[Docket No. FAA-2012-0716; Directorate Identifier 2012-SW-011-AD; Amendment 39-17121; AD 2012-14-07]

Airworthiness Directives; Bell Helicopter Textron Canada Helicopters

2012-14-07 Bell Helicopter Textron

Figure 1 to Paragraph (f)

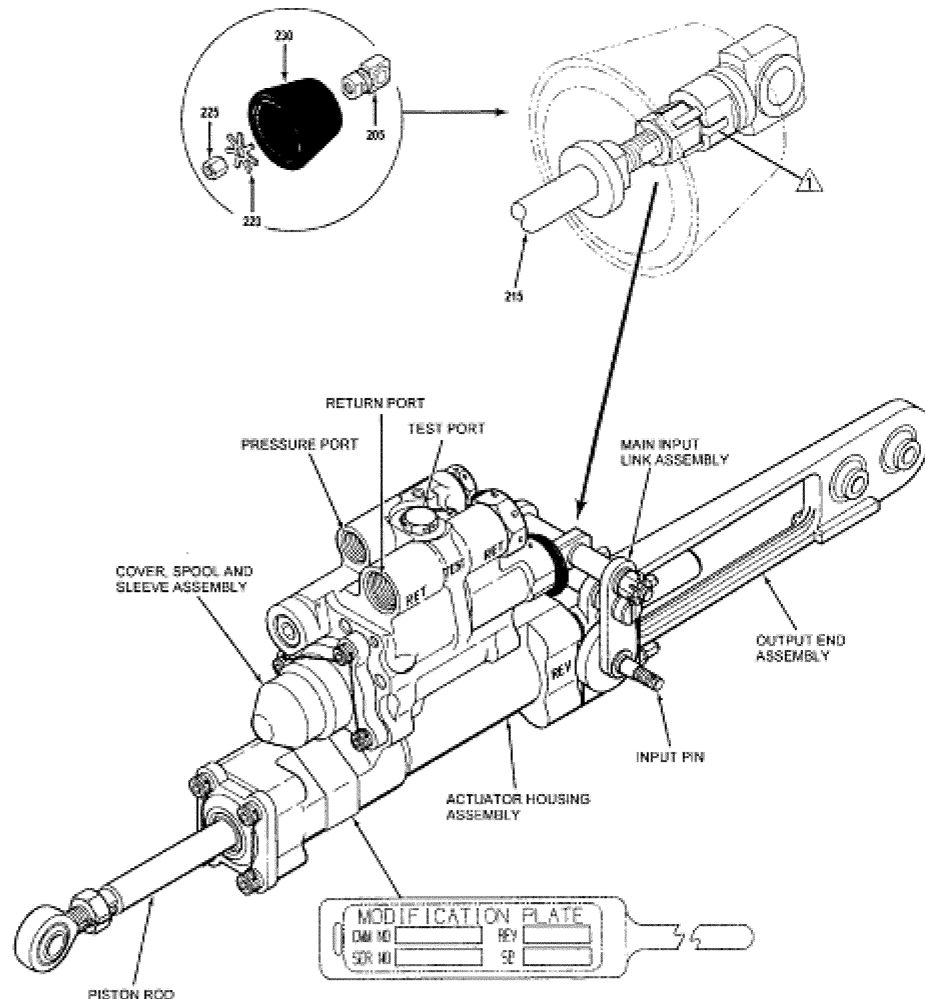
(i) Retract the boot depicted as 230 in Figure 1 to Paragraph (f) of this AD.

(ii) Applying only hand pressure, determine whether the nut, the shaft, or the clevis assembly, depicted as items 225, 215 and 205, respectively, in Figure 1 to Paragraph (f) of this AD, turn independently.

(iii) If the shaft does not turn independently, inspect to determine if at

least one tab of the lock washer is bent flush against a flat surface of the nut and if at least one tab of the lock washer is bent flush against a flat surface of the clevis assembly.

(iv) If at least one lock washer tab is not aligned and bent flush with a nut flat surface and at least one lock washer tab is not aligned and bent flush with a flat surface of the clevis assembly, before further flight, replace the servo with an airworthy servo.

(v) If any tab of the lock washer is not bent flush against either a flat surface of the nut or clevis assembly, bend the tab flush against a flat surface.
